# PERMIT

SEWAGE DISPOSAL SYSTEM

SUBDIVISION Ritz Estates ROAD Moss Meadow Way LOT 4, Blk.B

SITE PLAN LOT 4-B  
 RITZ ESTATES  
 DIST. 4 CARROLL CO. MD.

PERMIT CARD

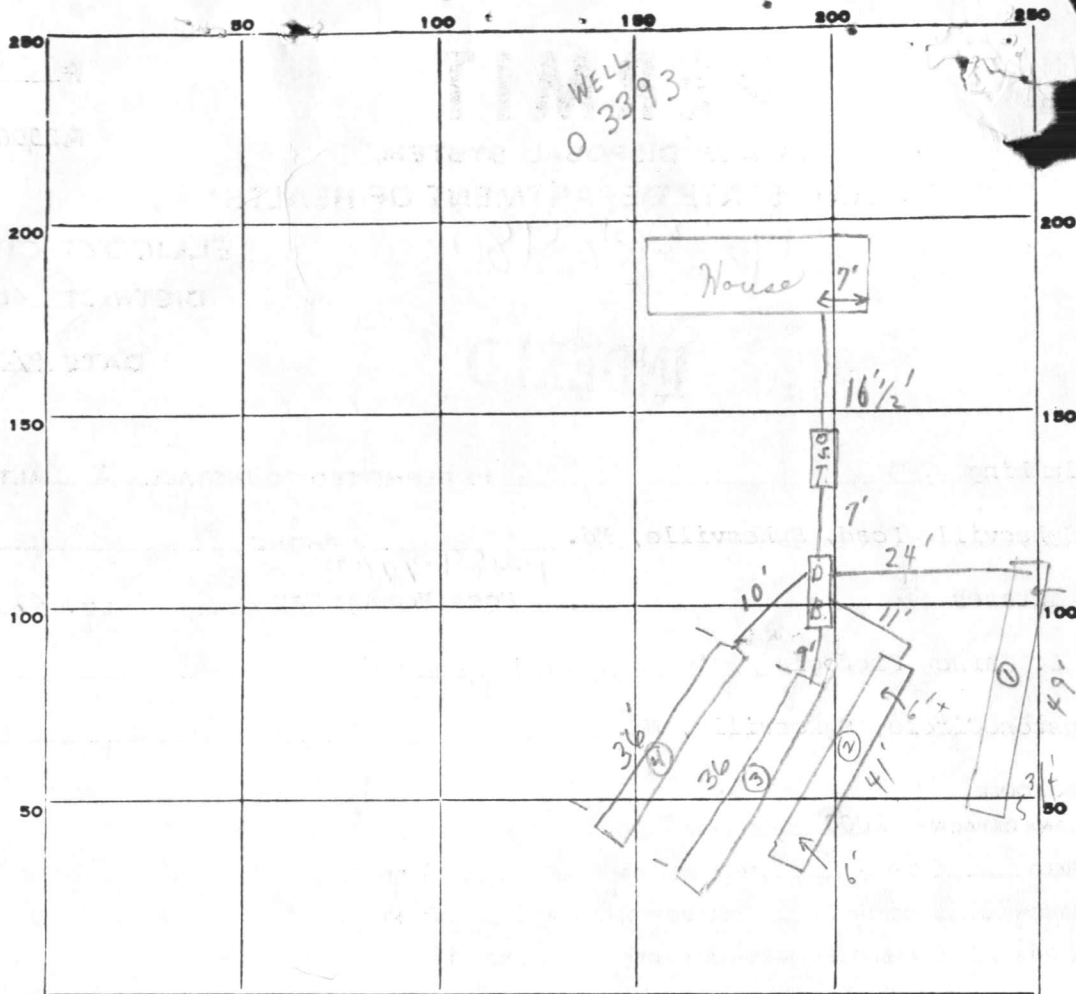
REMARKS 10/23/79 ok for stones in trench ① + ②; NO PIPES CEMENTED

10/24/79 TRENCH 3<sup>#4</sup> OK FOR GRAVEL OK TO BACK FILL #① & ② C.B.

SEE HOUSE CONN. & BAFFLE IN DIST. BOX. R.N. 10/24/79 P.M. System

DATE SYSTEM APPROVED 10/24/79 as per above

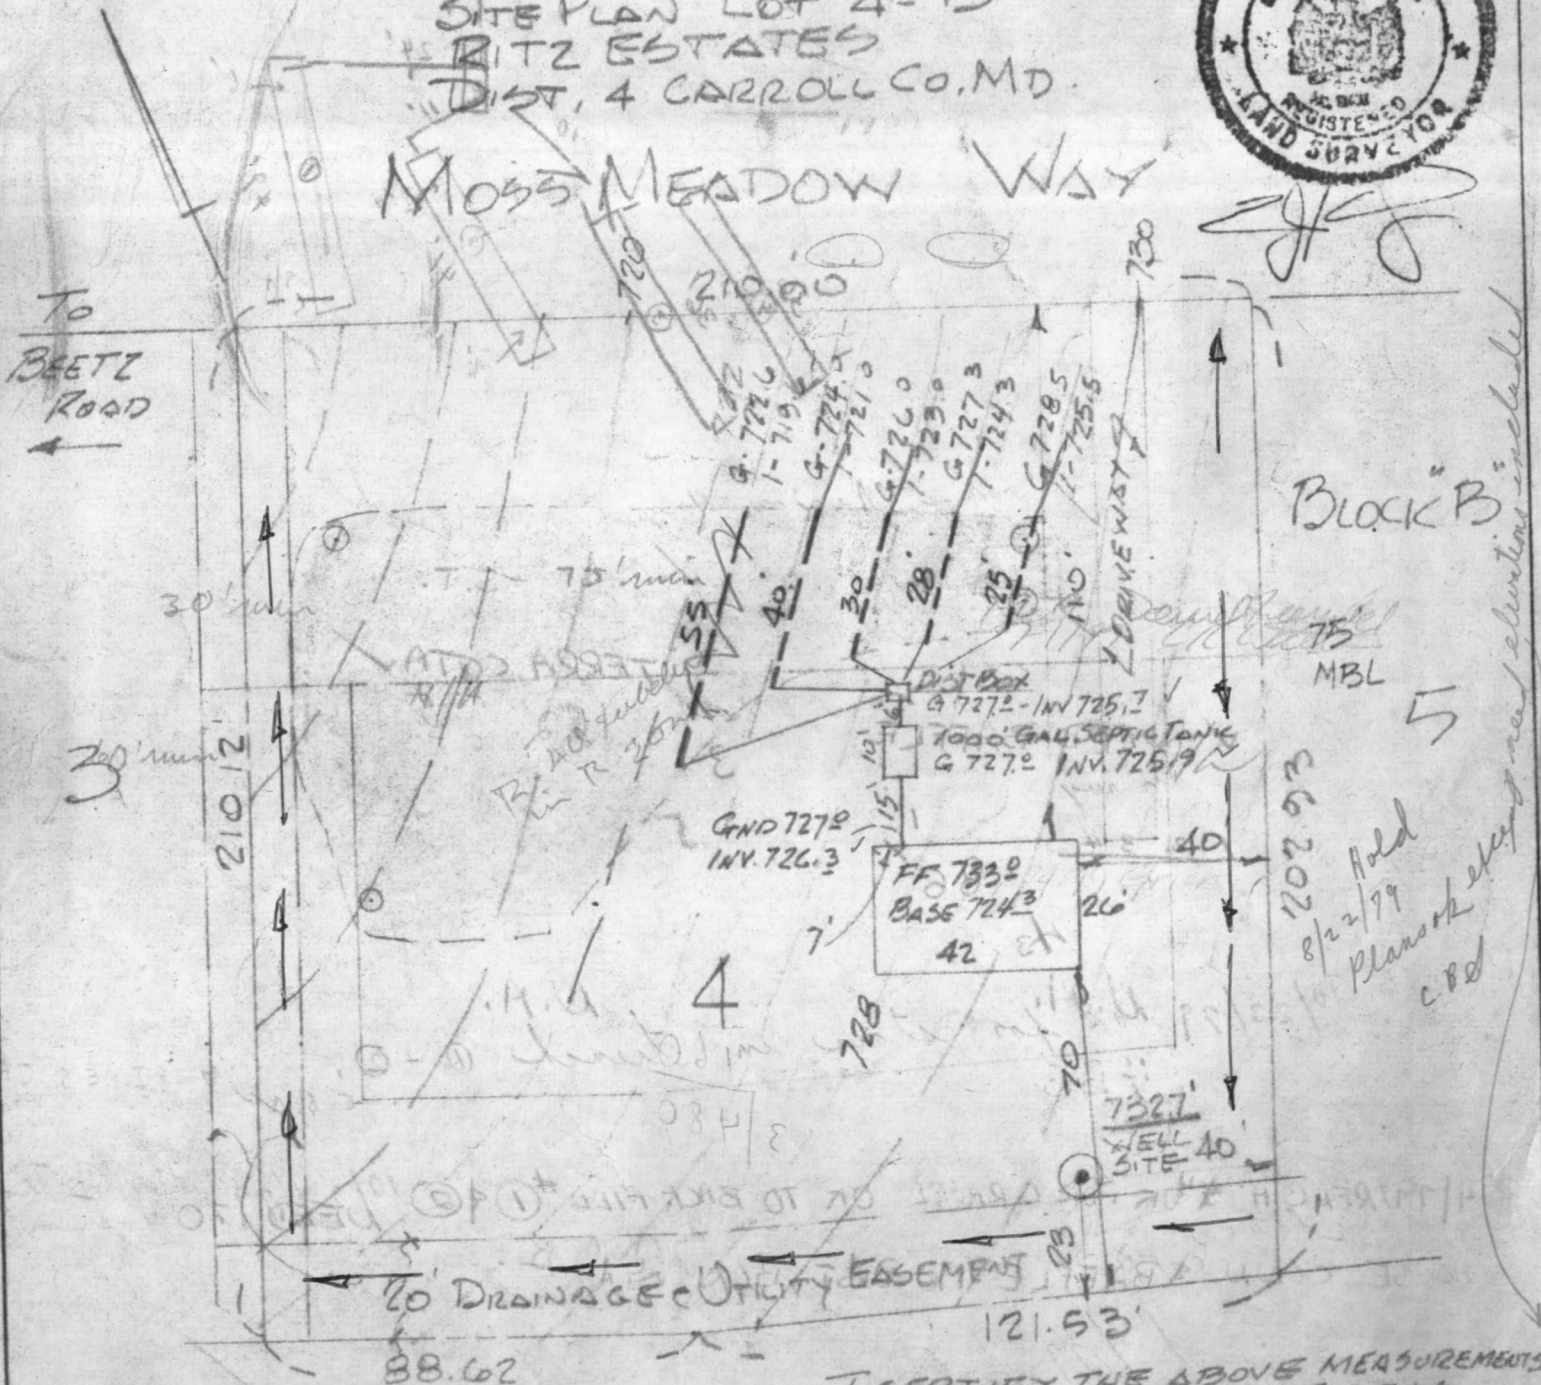
DRAINFIELD 4" PERFORATED PIPE 3' BELOW SURFACE, 3' WIDE TRENCH ALONG CONTOUR, 5" DIA PIPE TO DIST. BOX

# #4 B

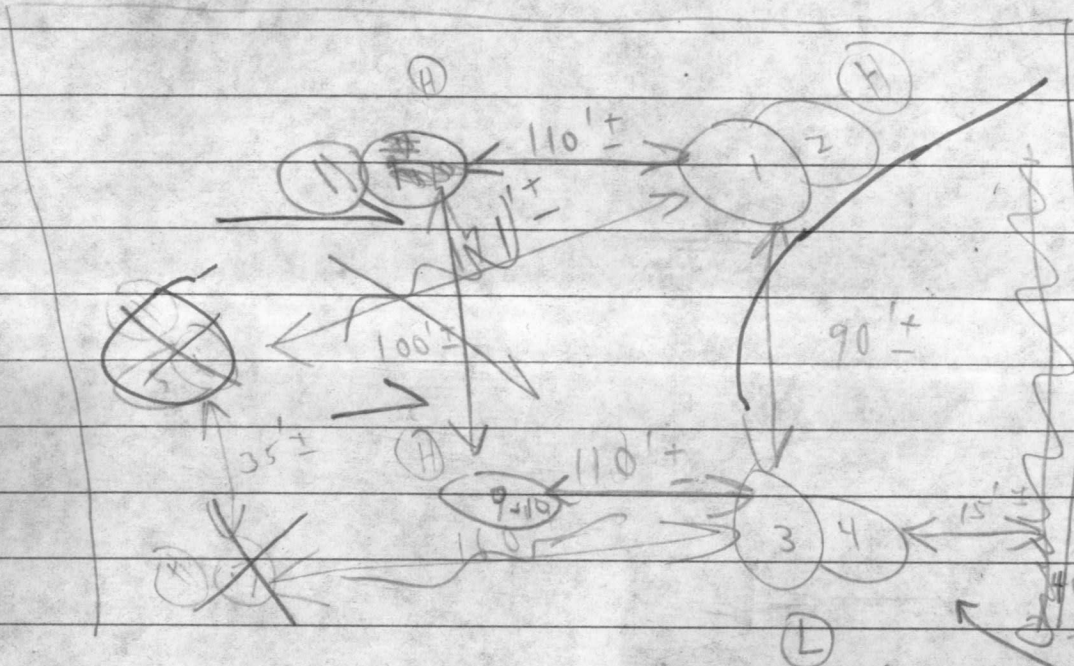
Failed some spots & depth  
for F.S.

Use either  
(9.10) (11)

Below clay loam + weathered shale depth ± 2.75

OK  
JRM
